ENGINEER'S TCL CERTIFICATION FOR TEMPORARY CERTIFICATE OF OCCUPANCY

SITE PLAN / TRAFFIC CIRCULATION LAYOUT (TCL)
ALBUQUERQUE SAFE CO.

PAVING SECTIONS AND DETAILS
ALBUQUERQUE SAFE CO.

ENGINEER'S GRADING CERTIFICATION

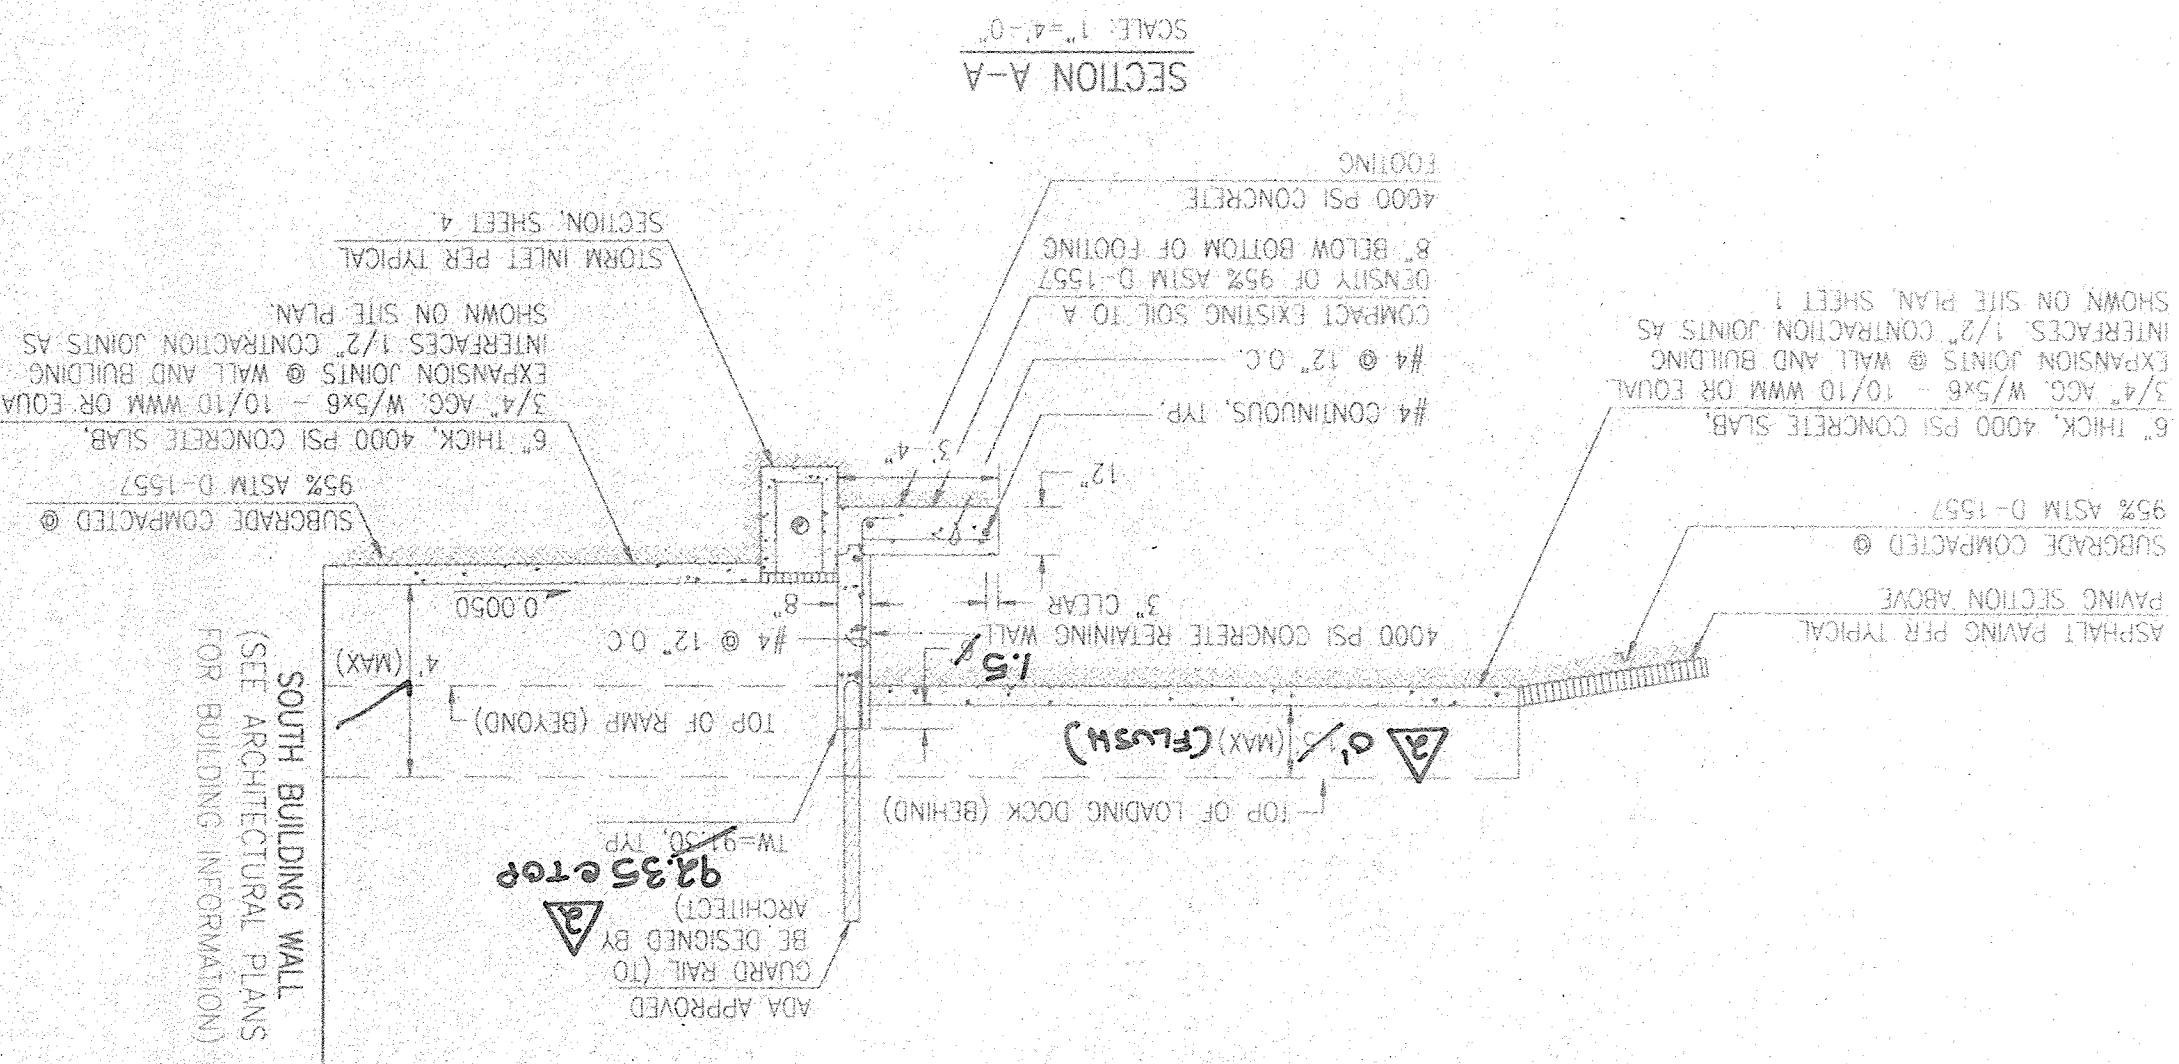
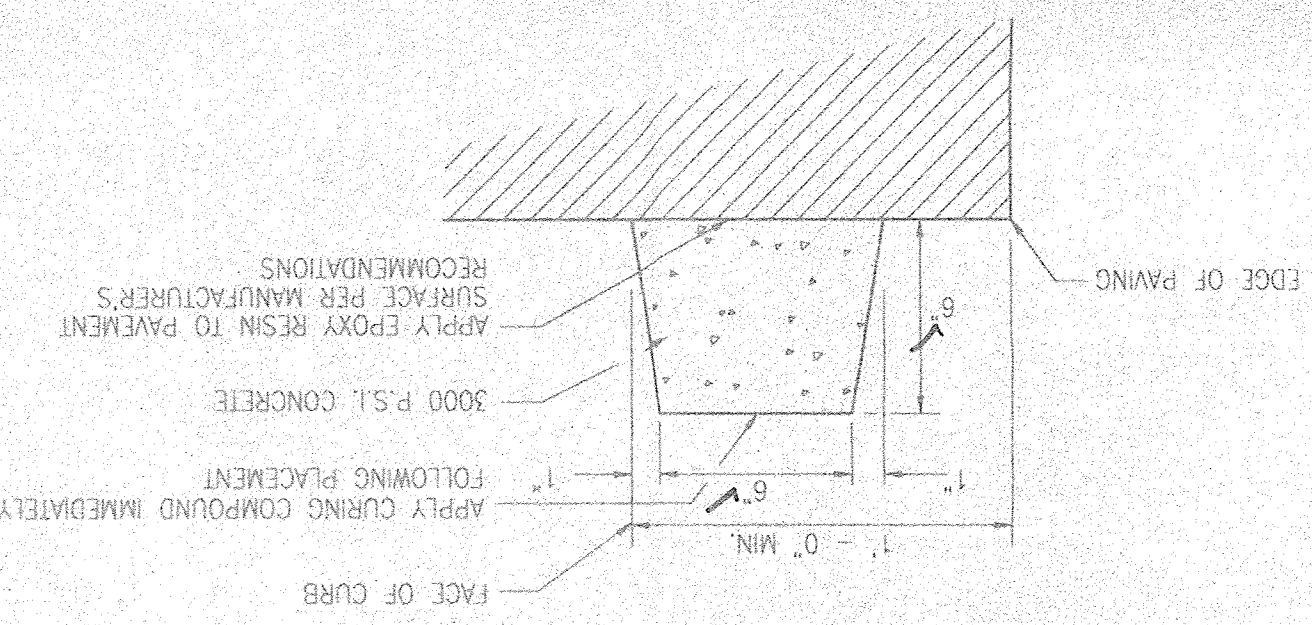
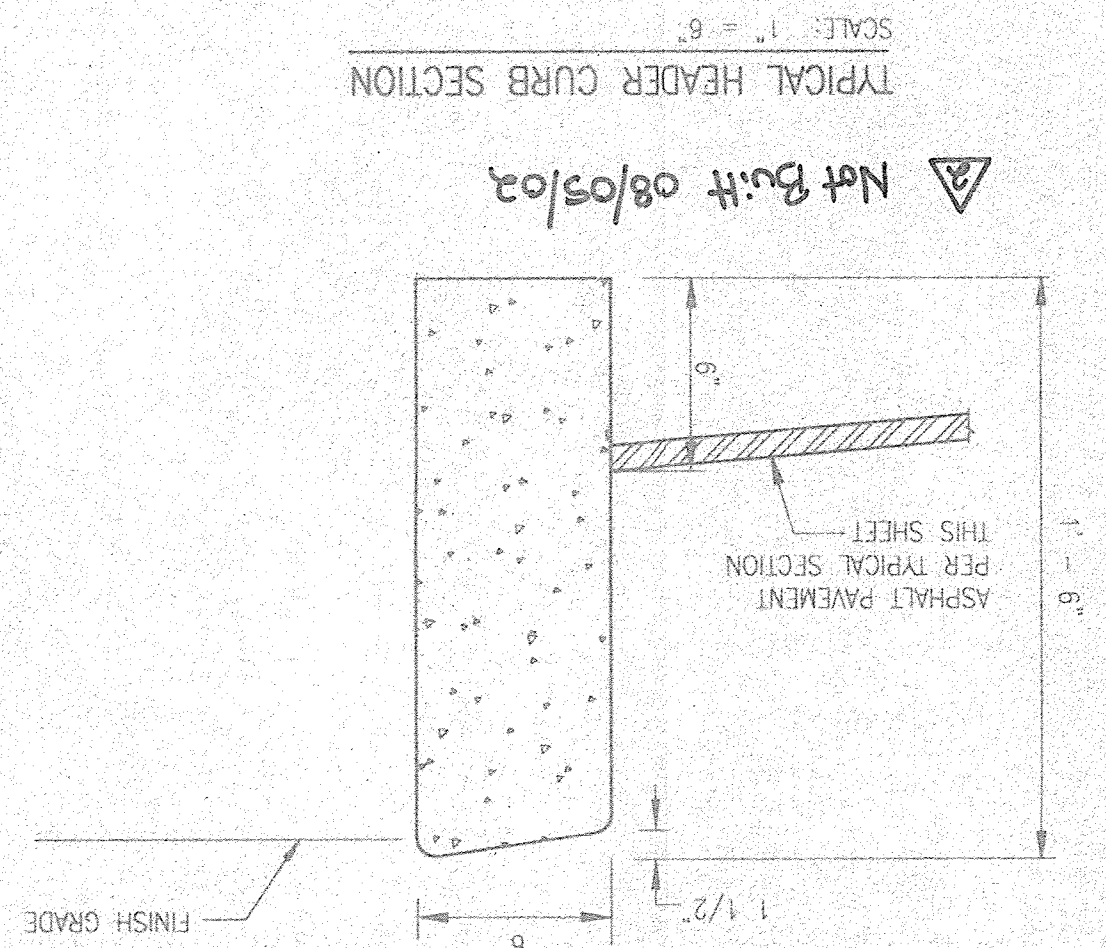
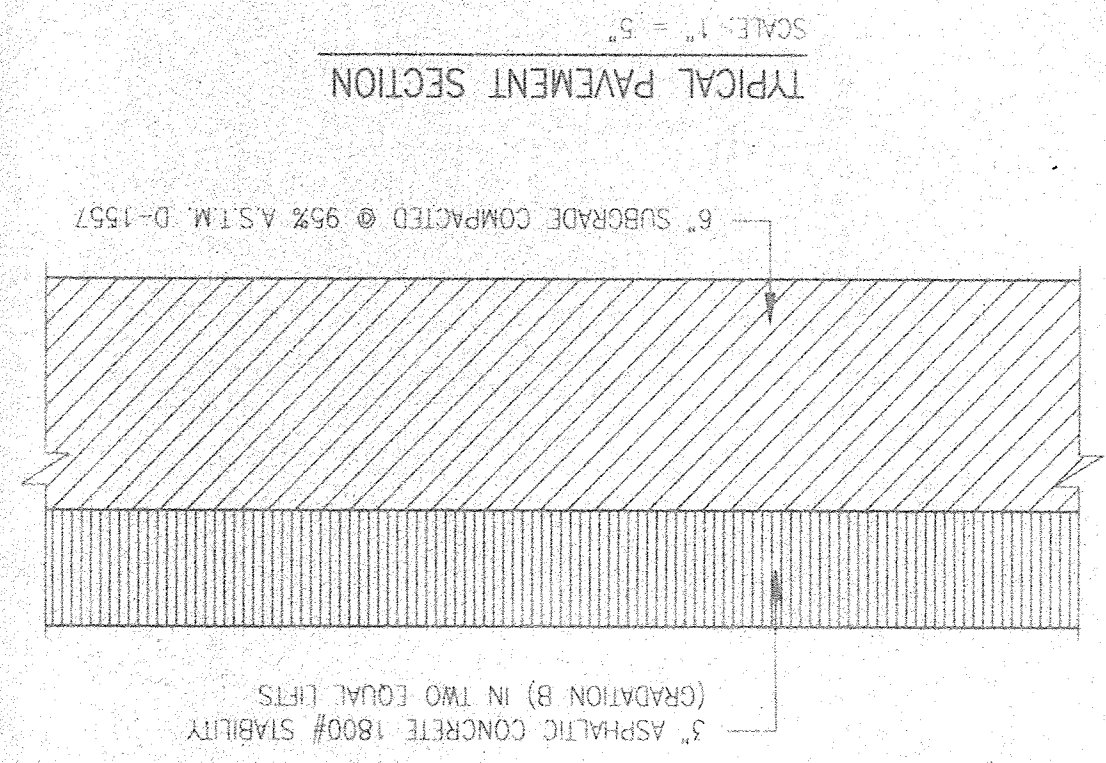
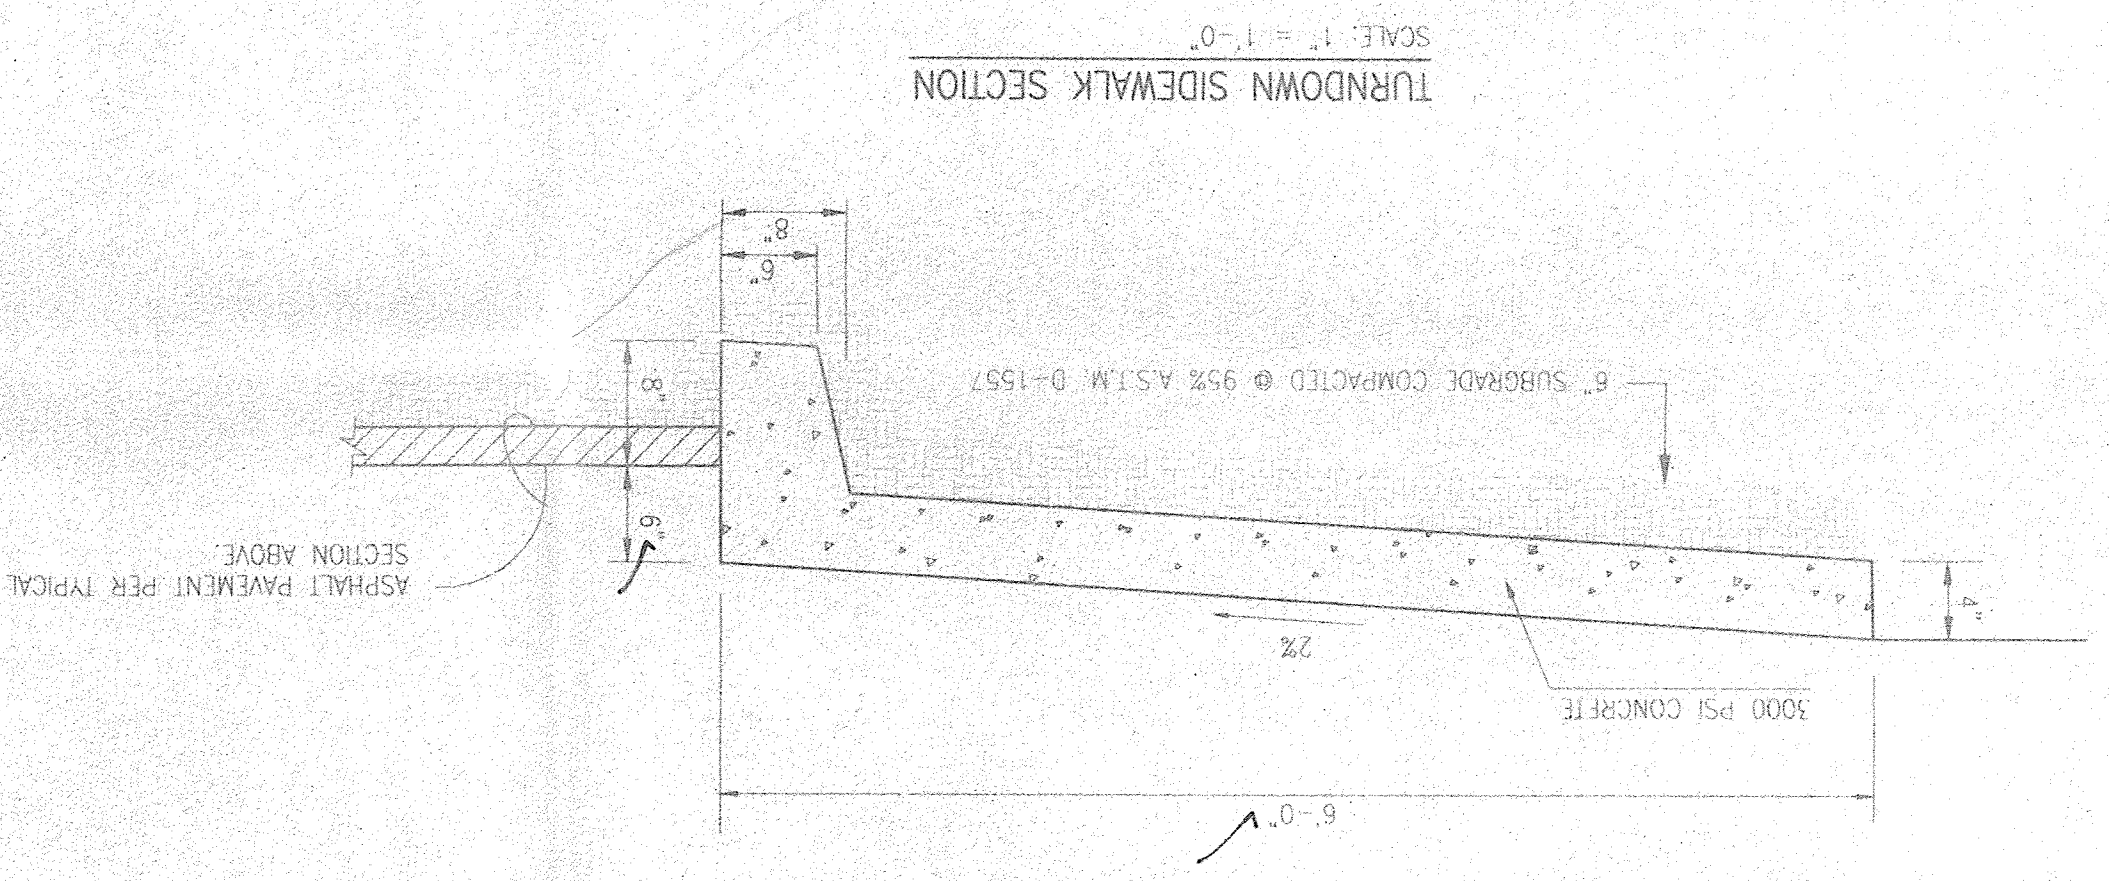
- 1) THE 6" PRIVATE STORM DRAIN LINES WERE SPECIFIED AS DUCTILE IRON PIPE AND WERE CONSTRUCTED AS PVC. THIS DEVIATION HAS NO ADVERSE EFFECT ON PIPE CAPACITY, BUT THE OWNER MAY EXPERIENCE ADDITIONAL MAINTENANCE AND A REDUCED LIFE CYCLE FOR THE PIPE DUE TO THE ANTICIPATED REPEATED HEAVY TRUCK LOADS.
- 2) THE GRADES AROUND THE PAVED DETENTION POND SURROUNDING THE SOUTHERNMOST STORM INLET WERE CONSTRUCTED SIGNIFICANTLY HIGHER THAN THOSE ON THE DRB APPROVED PLAN RESULTING IN A 50% REDUCTION IN POND CAPACITY. FORTUNATELY, THE ORIGINAL POND DESIGN WAS CONSERVATIVE AND THE AS-CONSTRUCTED POND VOLUME SATISFIES THE INTENT OF THE APPROVED PLAN AND DOES NOT REQUIRE REMOVAL AND REPLACEMENT OF THE PAVEMENT TO PROVIDE ADDITIONAL CAPACITY.

- 1) THE CONTRACTOR DID NOT CONSTRUCT THE GRADED FLOWLINE AROUND THE EAST AND NORTH SIDES OF THE BUILDING AS SHOWN ON THE DRB APPROVED PLAN. THIS FLOWLINE WAS REQUIRED BY THE BN&SF RAILROAD TO PREVENT DEVELOPED RUNOFF FROM ENTERING THE RAIL SPUR EASEMENT. THIS FLOWLINE MUST BE CONSTRUCTED IN ACCORDANCE WITH THE APPROVED PLAN AND RE-CERTIFIED.

- 2) THE CONTRACTOR DID NOT CONSTRUCT THE CURB OPENING AT THE NORTHEAST CORNER OF THE PARKING LOT SHOWN ON THE DRB APPROVED PLAN TO ACCEPT DRAINAGE FROM THE AFOREMENTIONED FLOWLINE. THIS OPENING MUST BE CONSTRUCTED IN ACCORDANCE WITH THE APPROVED PLAN AND RE-CERTIFIED.

- 3) THE CONTRACTOR DID NOT CONSTRUCT THE HEADER CURB SPECIFIED ALONG THE SOUTH EDGE OF THE PAVEMENT RESULTING IN THE POTENTIAL FOR POND OVERFLOW TO THE PRIVATE PROPERTY TO THE SOUTH INSTEAD OF TO THE PUBLIC STREET TO THE WEST. THE SOUTH CURB MUST BE CONSTRUCTED IN ACCORDANCE WITH THE APPROVED PLAN AND RE-CERTIFIED.

- 4) THE PRIVATE STORM DRAIN CONNECTION TO THE EXISTING CITY INLET AT THE NORTHWEST CORNER OF THE SITE REQUIRED AN S.O.19 PERMIT AND CITY INSPECTION. A SIGNED COPY OF THE CITY INSPECTOR'S APPROVAL MUST BE PROVIDED PRIOR TO RE-CERTIFICATION.

- 1) THE GRADED FLOWLINE AROUND THE EAST AND NORTH SIDES OF THE BUILDING HAS BEEN CONSTRUCTED AND A STEEL LANDSCAPING EDGE HAS BEEN PROVIDED TO FURTHER PREVENT RUNOFF FROM ENTERING THE RAIL SPUR EASEMENT.
- 2) THE CURB OPENING AT THE NORTHEAST CORNER OF THE PARKING LOT HAS BEEN CONSTRUCTED.
- 3) THE SOUTH CURB HAS BEEN RAISED TO THE MINIMUM REQUIRED ELEVATION AND NOW SATISFIES THE INTENT OF THE APPROVED PLAN.
- 4) THE PRIVATE STORM DRAIN CONNECTION AT THE NORTHWEST CORNER OF THE SITE REQUIRED AN S.O.19 PERMIT AND CITY INSPECTION. A SIGNED COPY OF THE CITY INSPECTOR'S APPROVAL IS PROVIDED HERewith.
